BSI Scope Final Design Changes

Arup Final Design Kick-Off Meeting

November 7, 2017

Underground Electrical

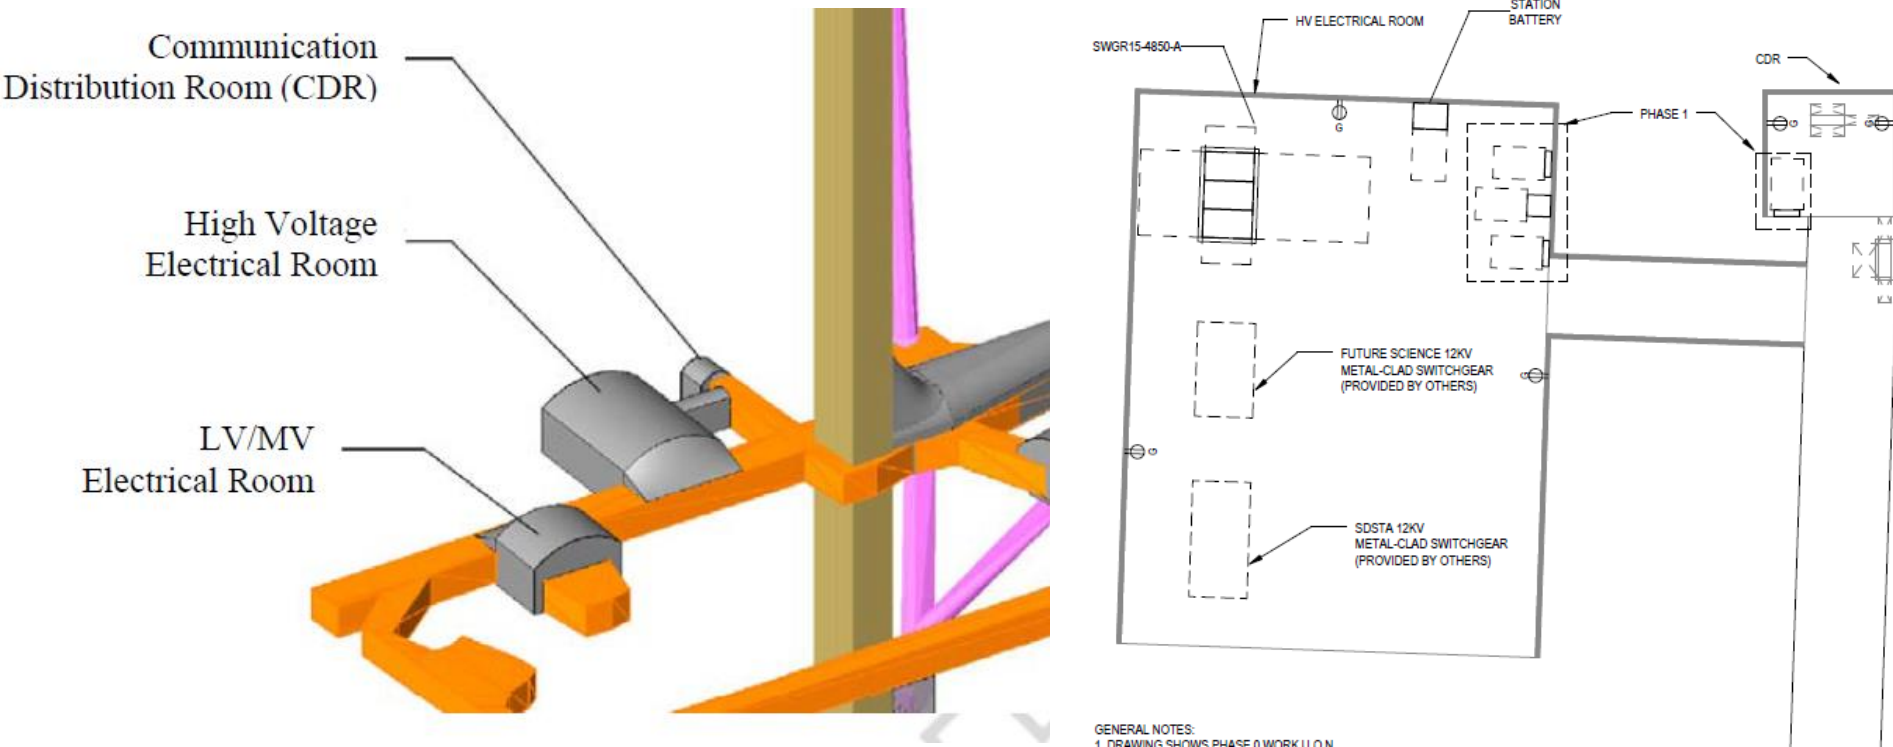
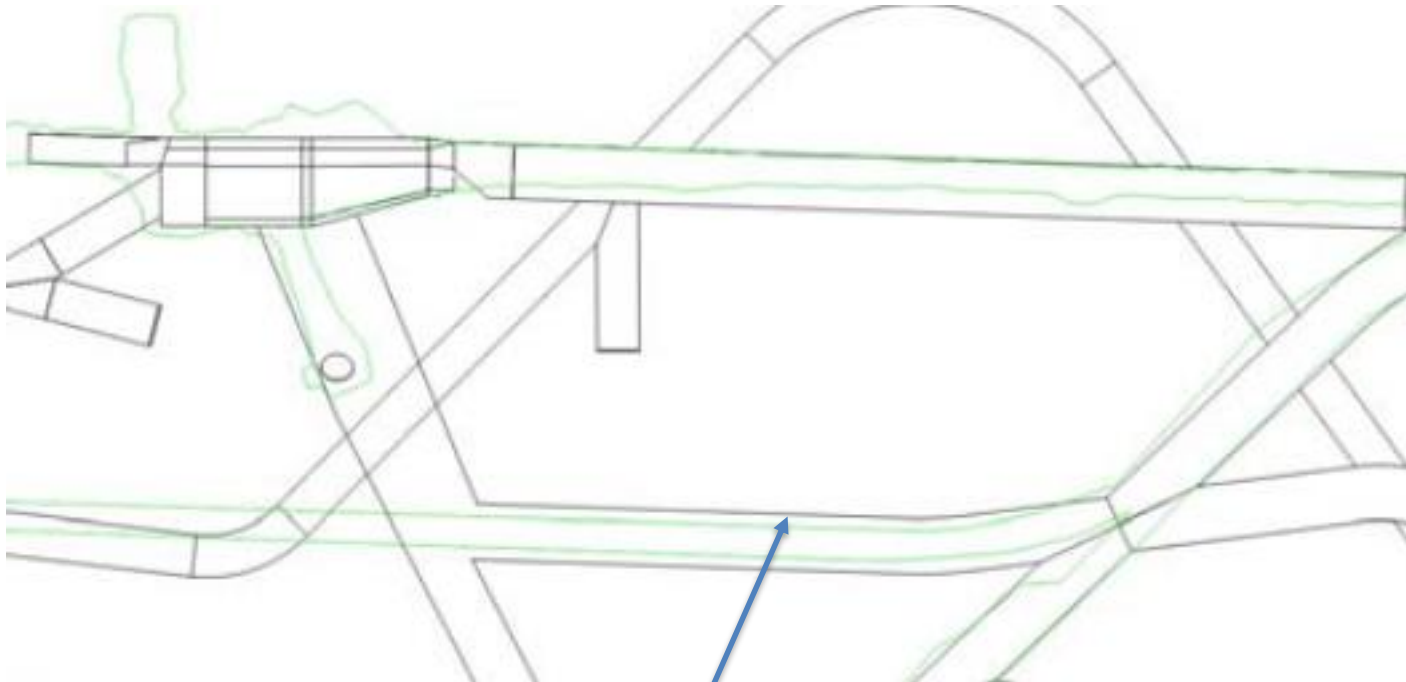
- Design for Underground Substation to be updated as per Advanced Preliminary Design Concept

- Design for Underground Substation to be updated as per Advanced Preliminary Design Concept
- Will also serve as Maintenance Shop during Excavation

Underground Architectural/Electrical/Mechanical

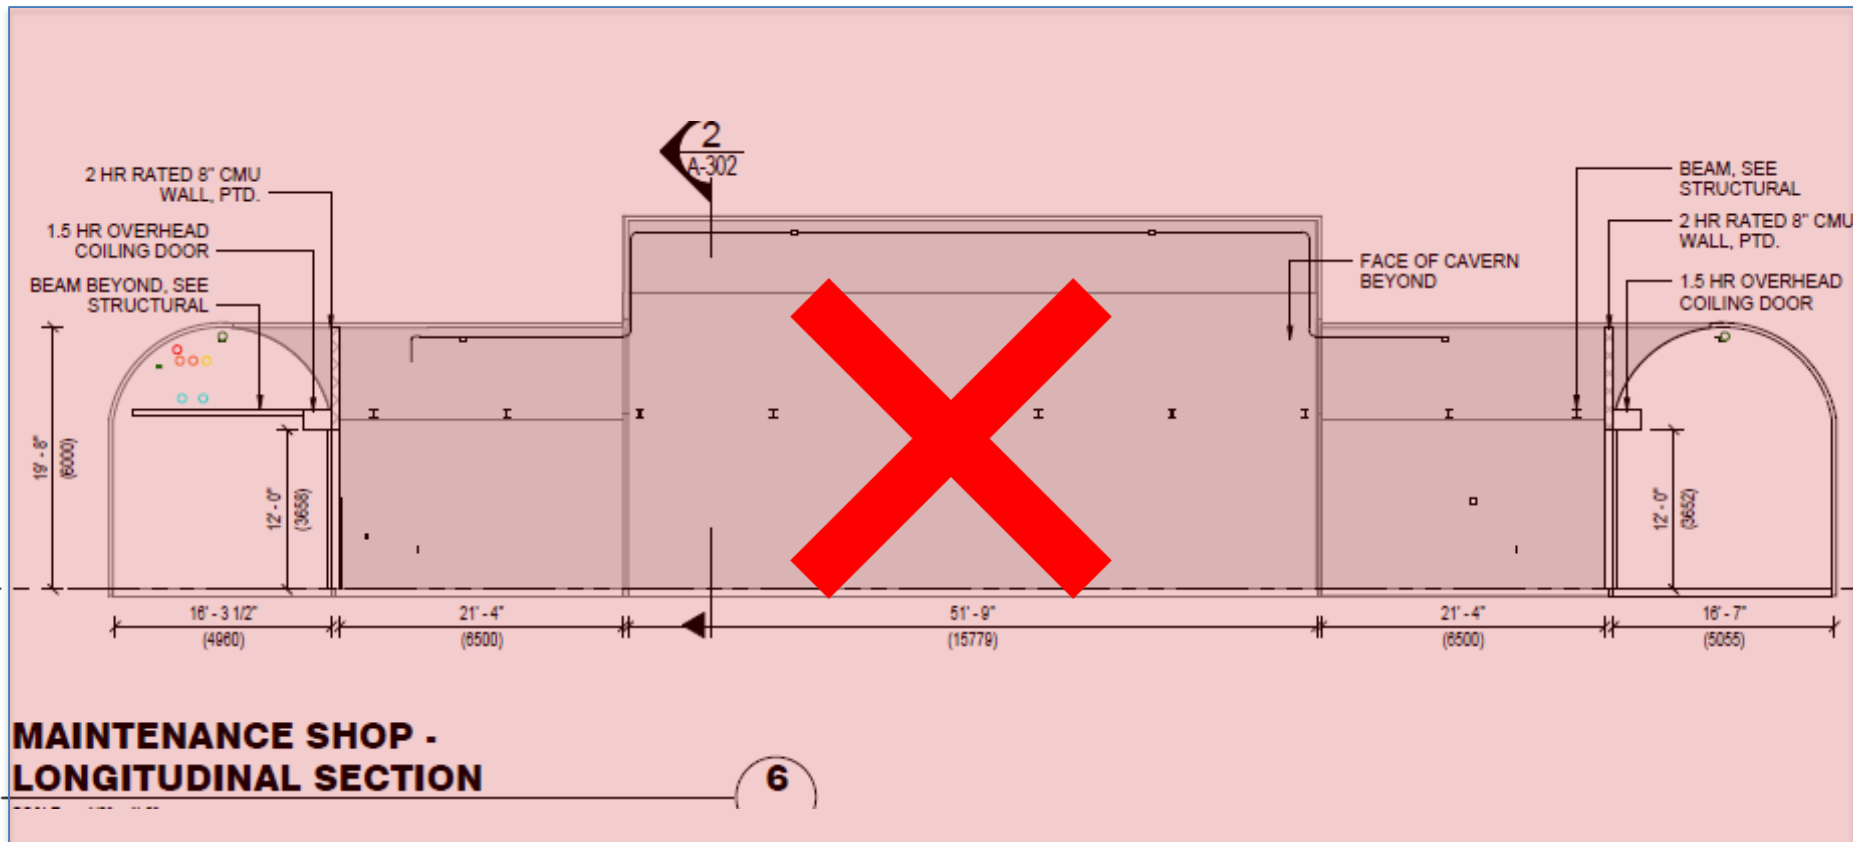
- Separate Maintenance Shop no longer required. Therefore, no additional BSI required for Maintenance Shop

BSI Scope Changes – Underground Structural

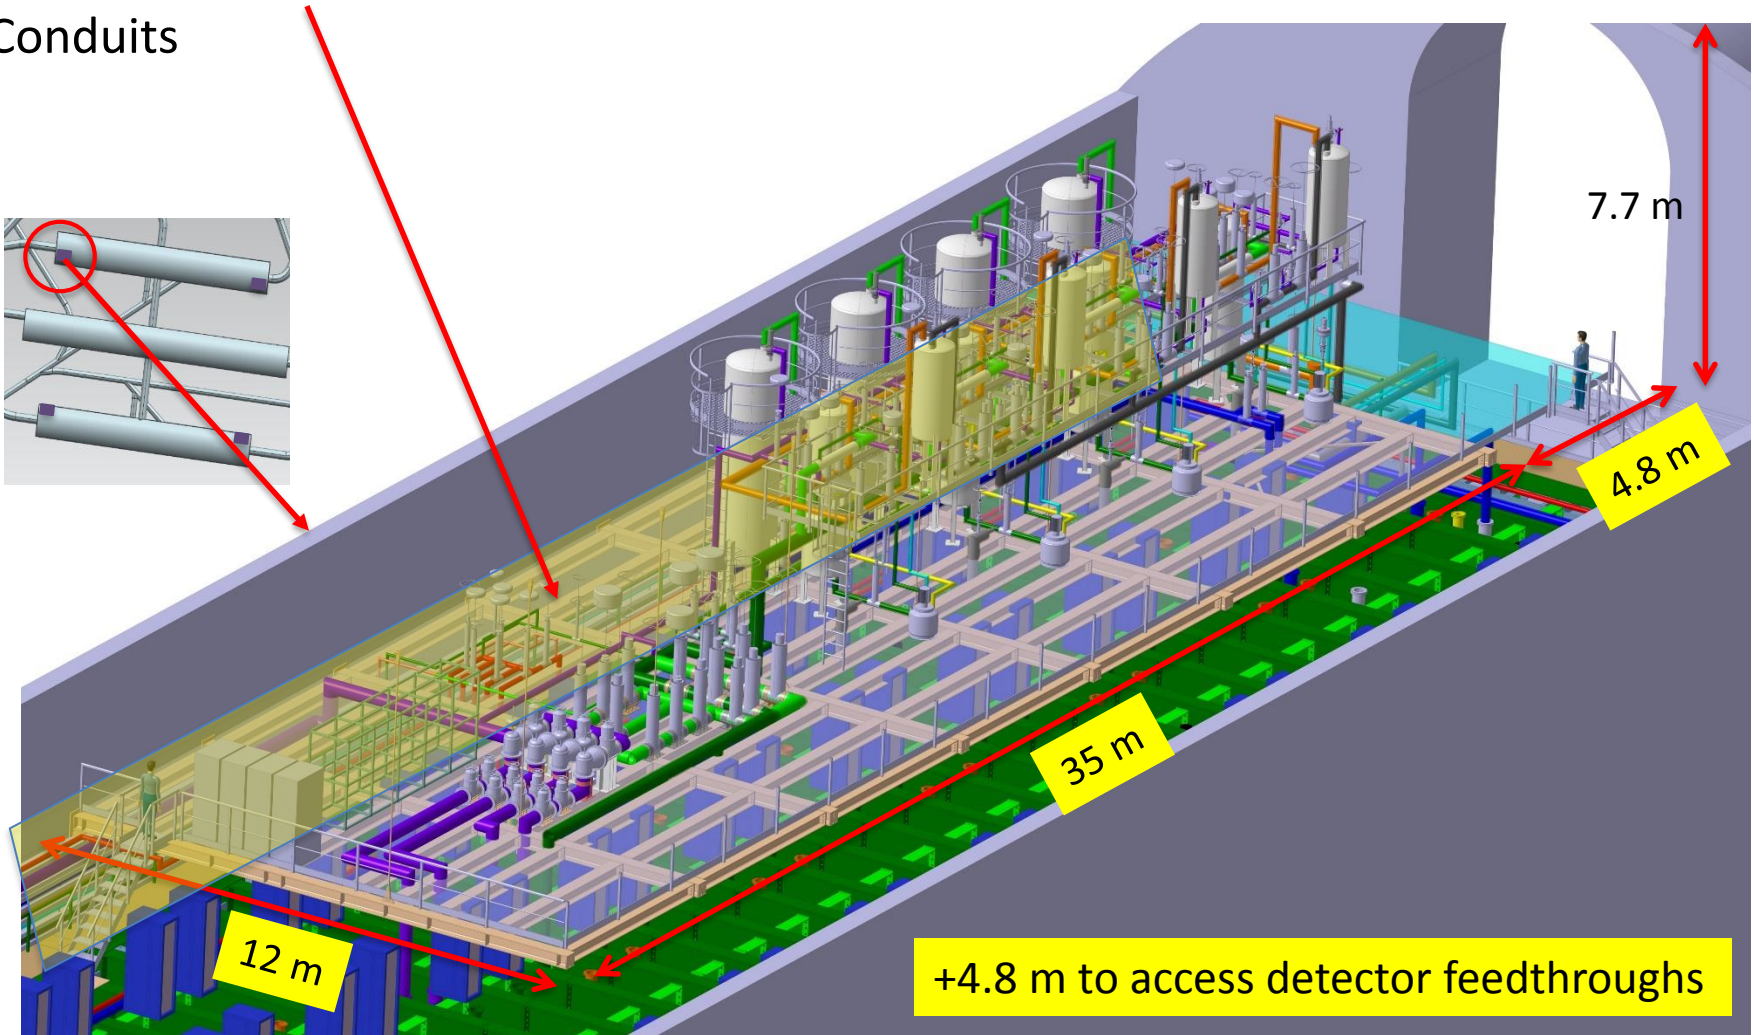
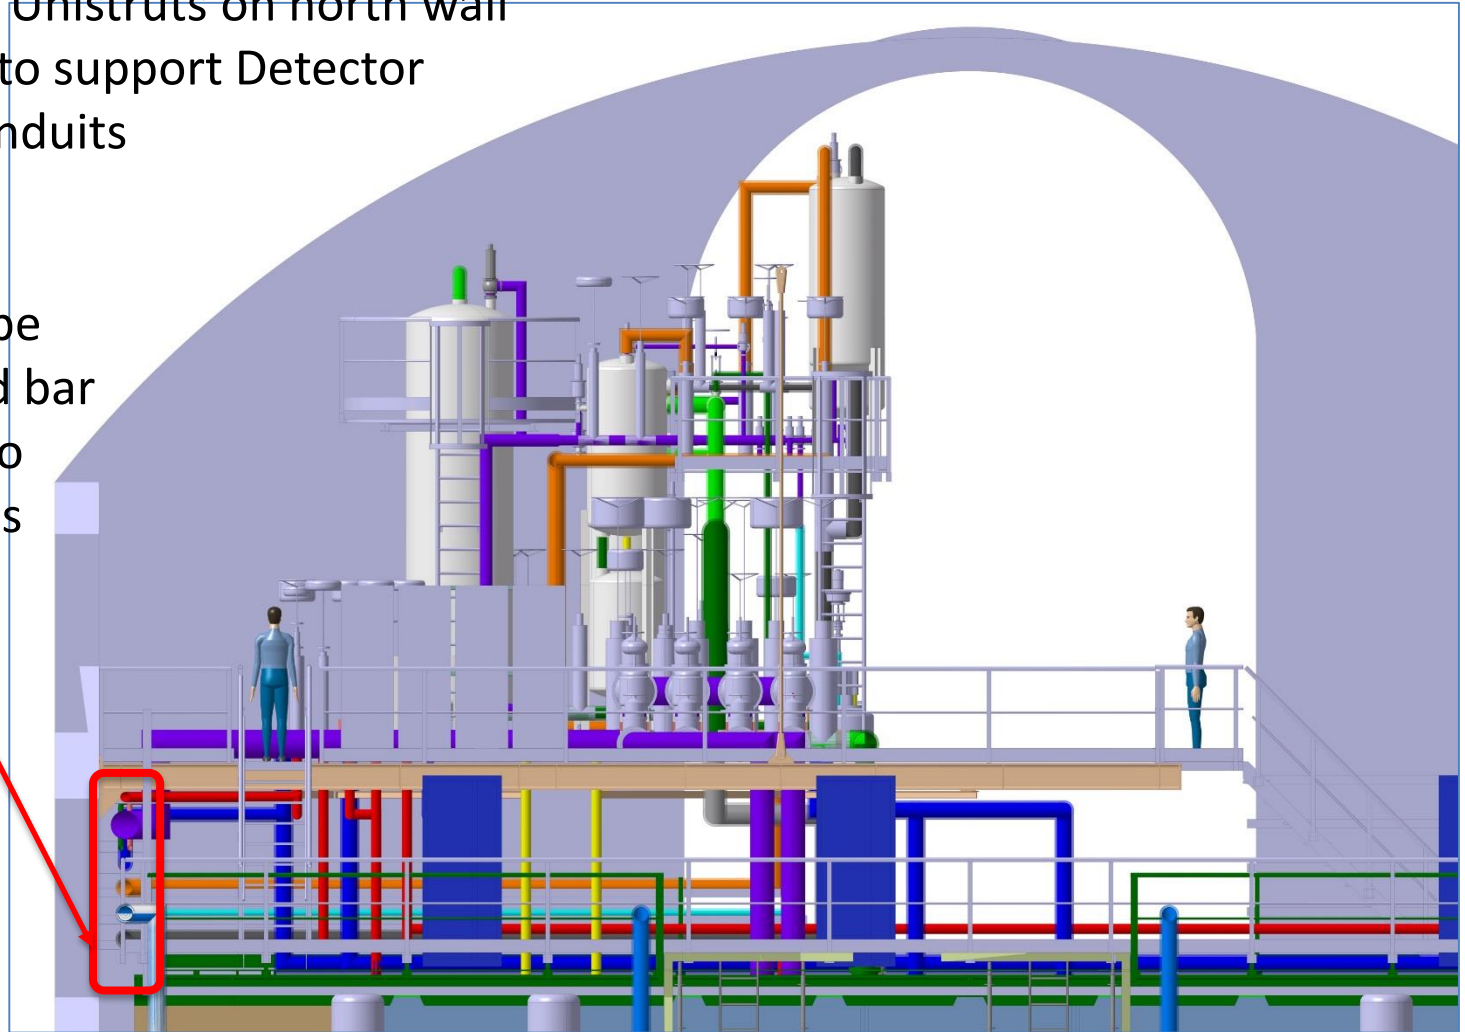
Add Vertical Unistruts on north wall of chamber to support Detector Pipe and Conduits

- Add Vertical Unistruts on north wall of chamber to support Detector Pipe and Conduits
- Height of Unistrut to be from ground bar to as close to spring line as possible

Underground Mechanical – Cryostat Ventilation

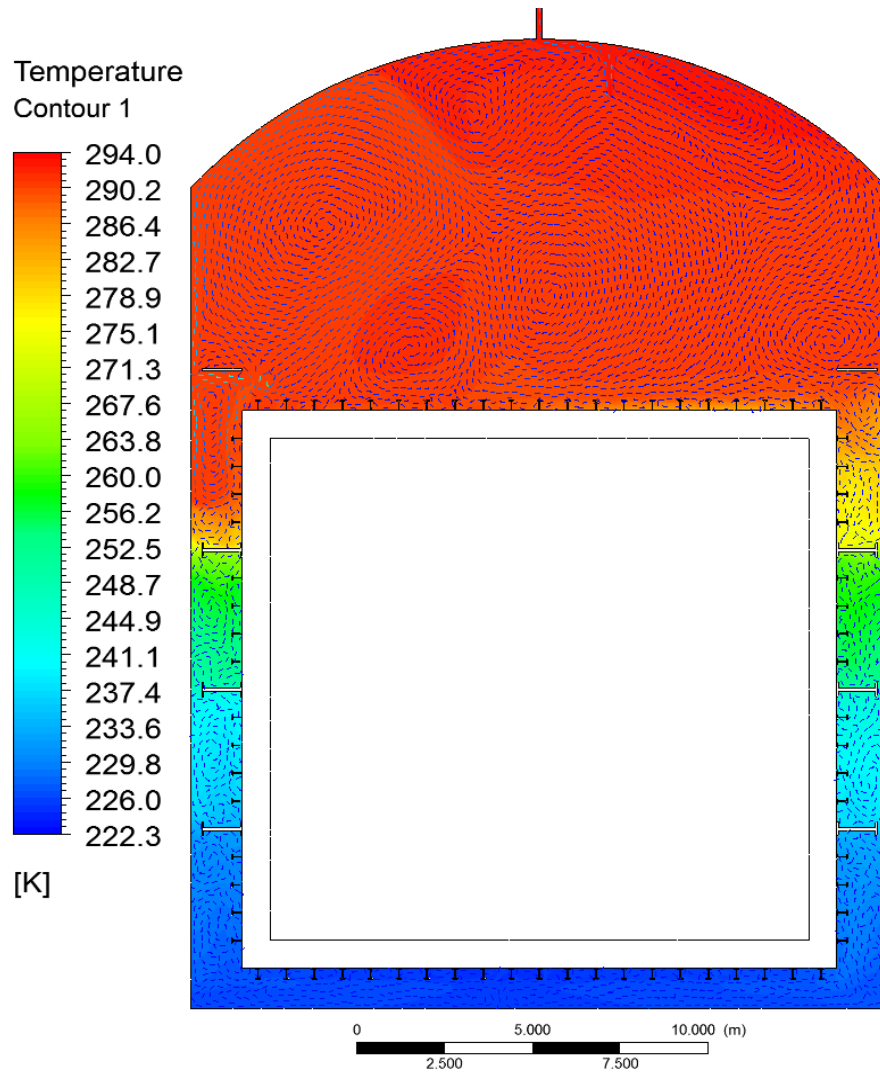
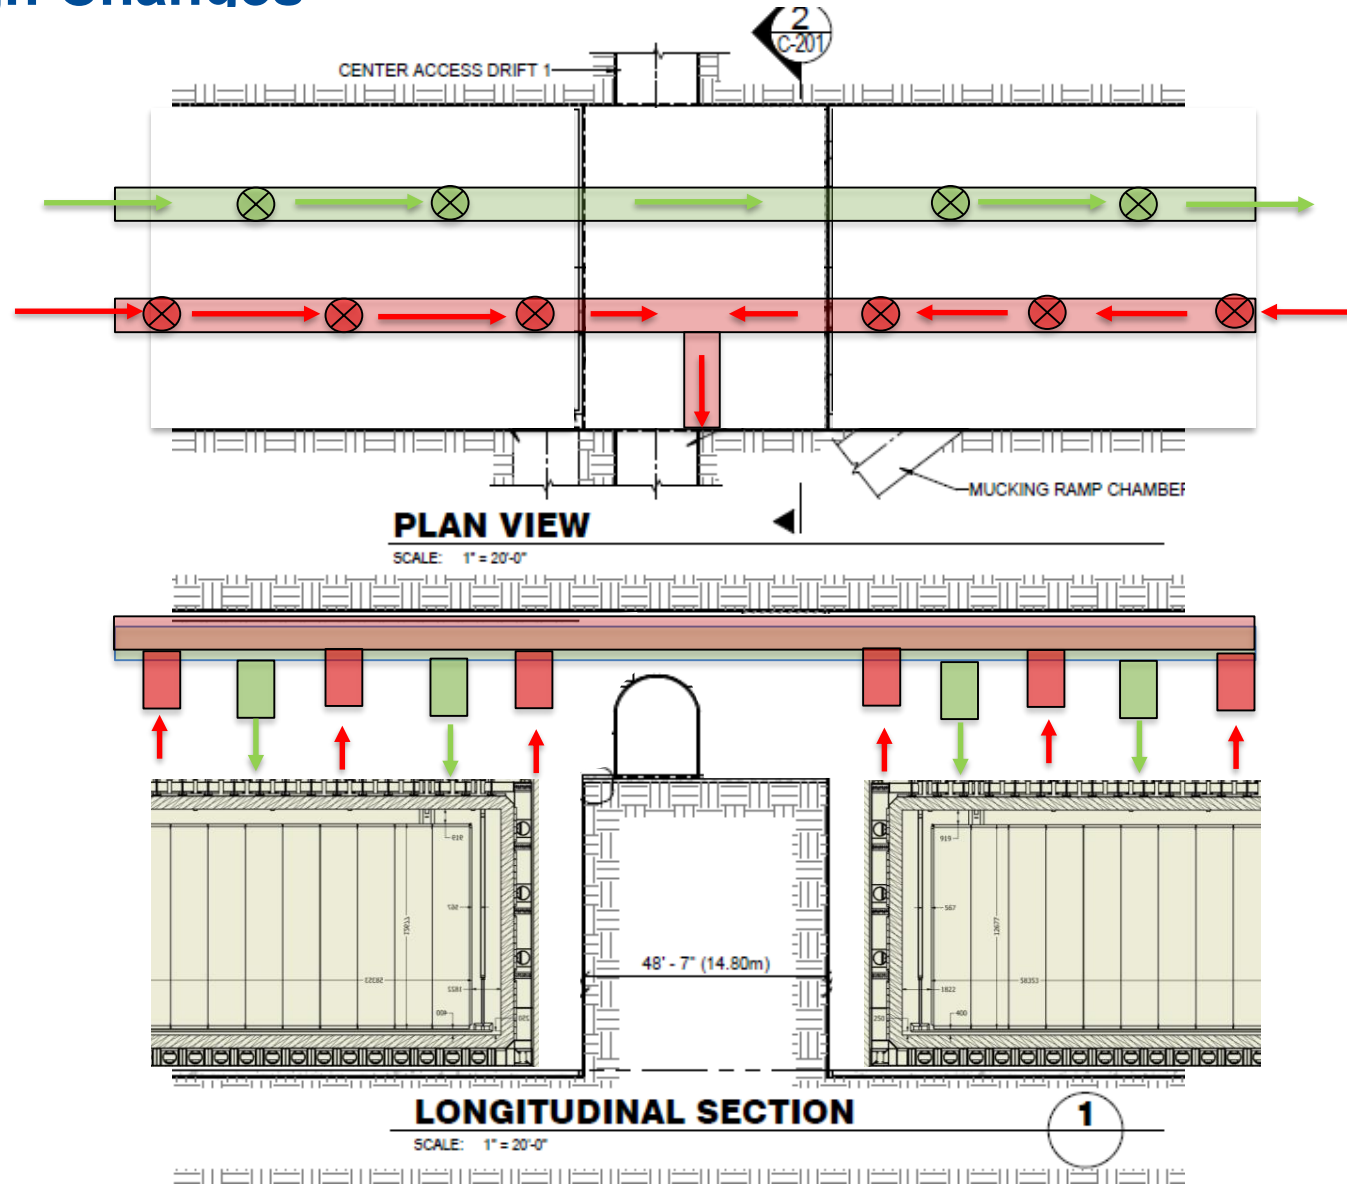
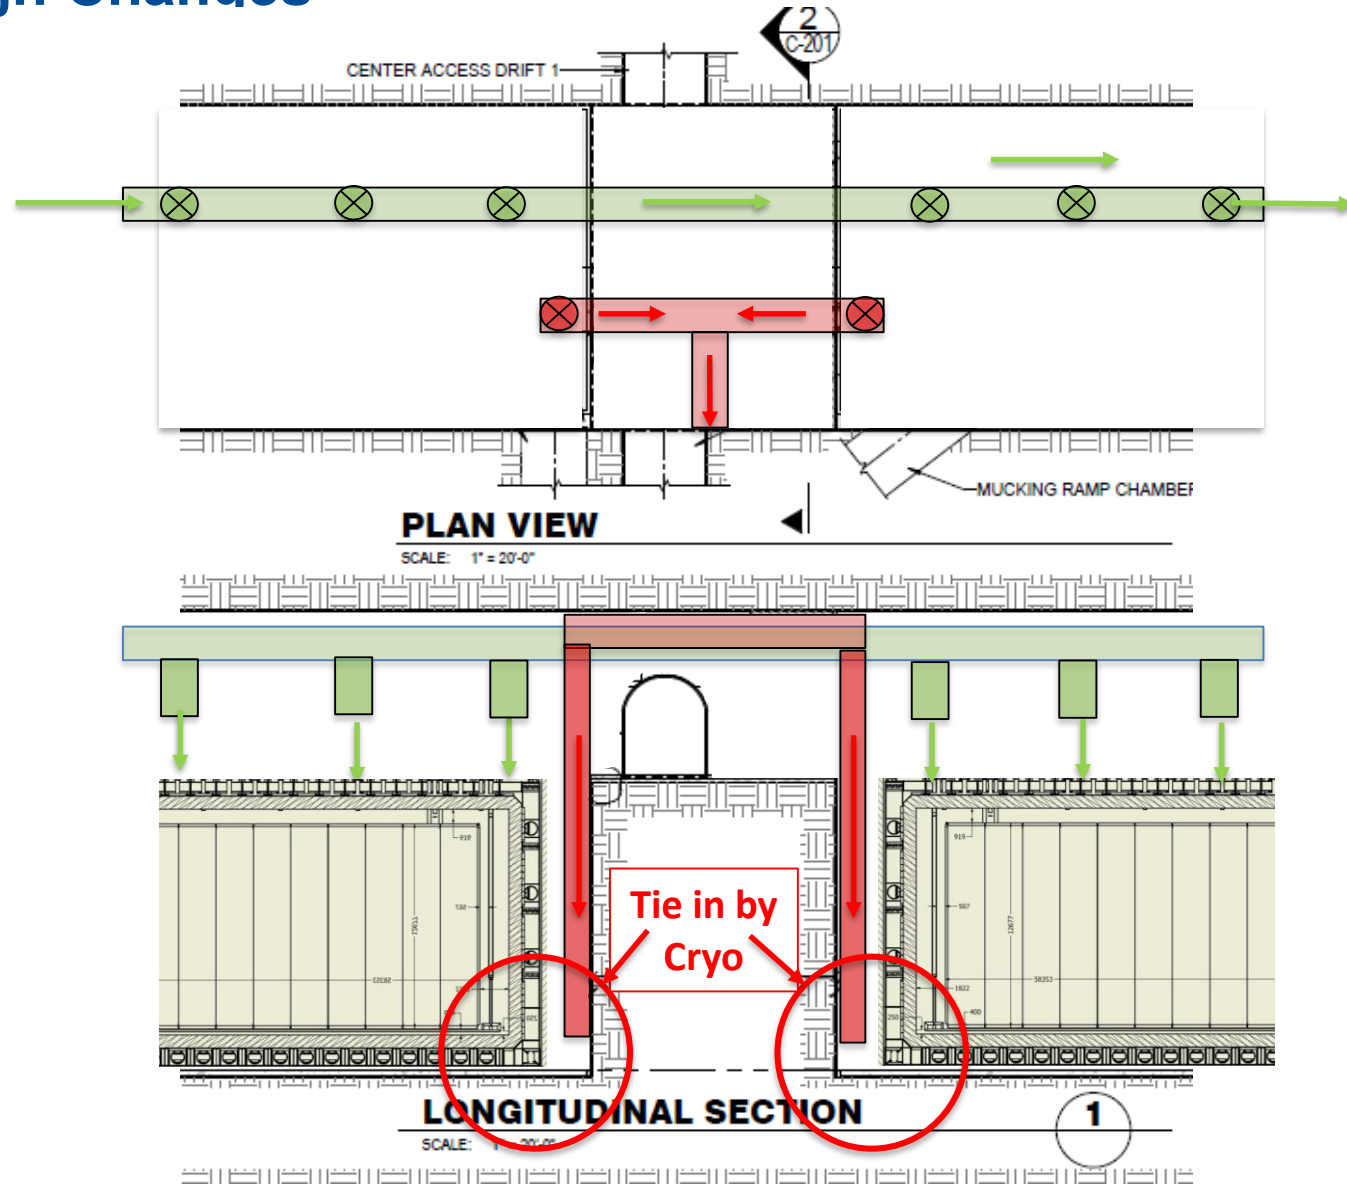
- A condensation analysis has been performed which has determined that the current Preliminary design for Cryostat ventilation does not provide for adequate circulation to prevent condensation from occurring

- Current Preliminary Design

- Required Final Design Arrangement
- Required for all 4 Cryostat Chambers
